# TECHNICAL SERVICE BULLETIN

## MIL With Misfire DTCs/Water In Spark Plug Wells And/Or Corrosion On Ignition System Components

**21-2147**

<b>Ford</b> 2019-2021 Ranger
---------------------------------

Figure 1

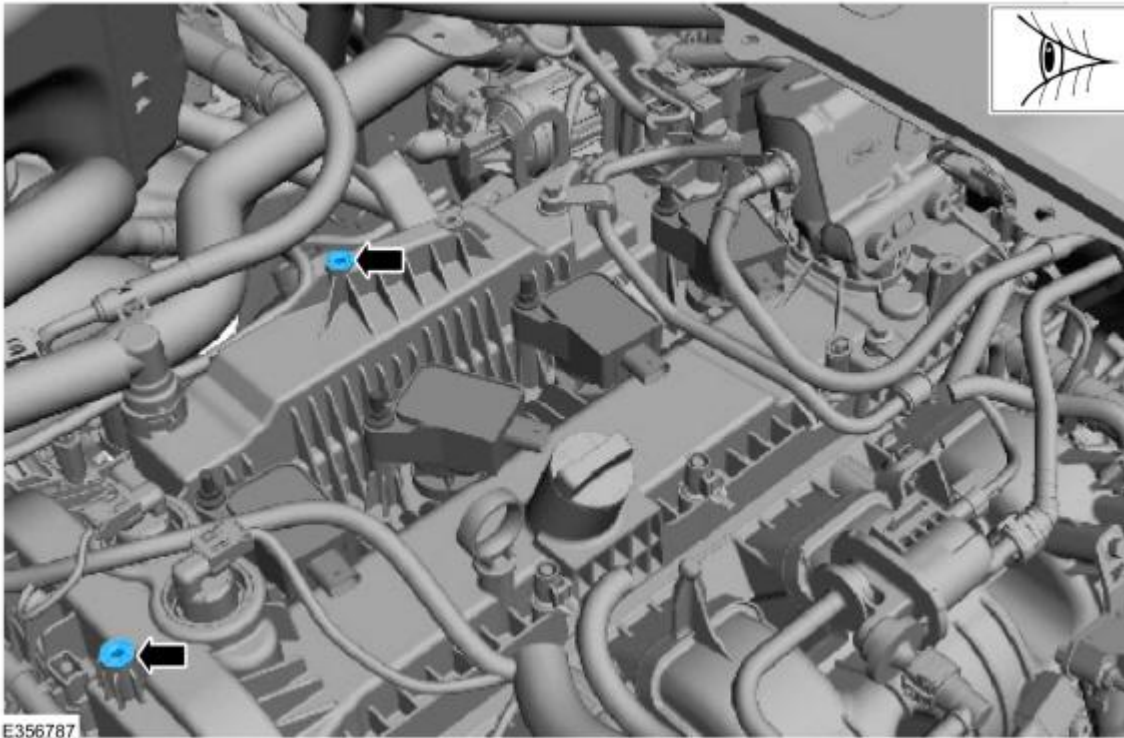
1. Resolve engine misfire DTCs P0300, P0301, P0302, P0303, P0304, and/or P0316 per normal diagnostics outside of this article. Refer to Powertrain Control/Emission Diagnosis (PC/ED) Manual. Proceed to Step 2.
2. Open the hood to access the engine compartment.
3. Locate the 2 engine appearance cover mounting bosses on the valve cover. (Figure 1)

Figure 2

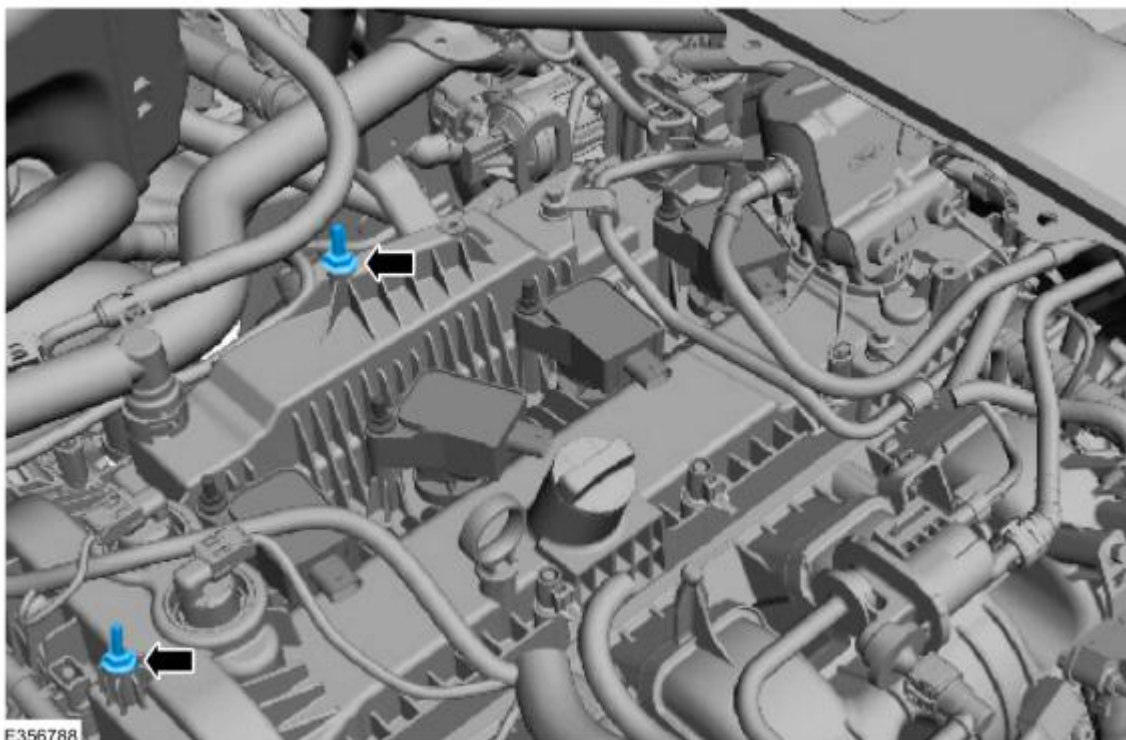
4. Install the 2 engine appearance cover stud bolts to the valve cover and tighten to 10 Nm (89 lb-in). (Figure 2)

Figure 3

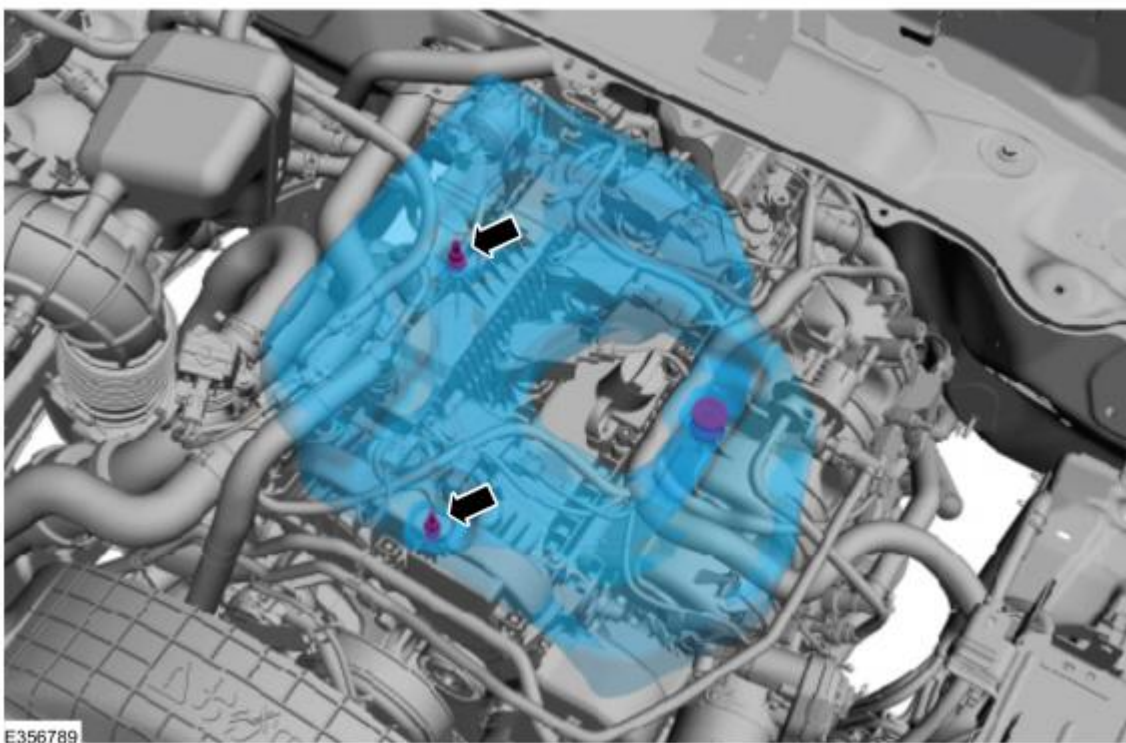
6. Install the engine appearance cover. (Figure 3)

Figure 4

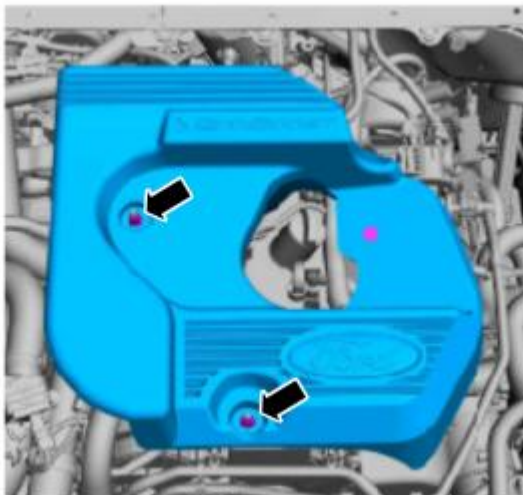
7. Install and tighten the 2 engine appearance cover nuts to 10 Nm (89 in-lb). (Figure 4)
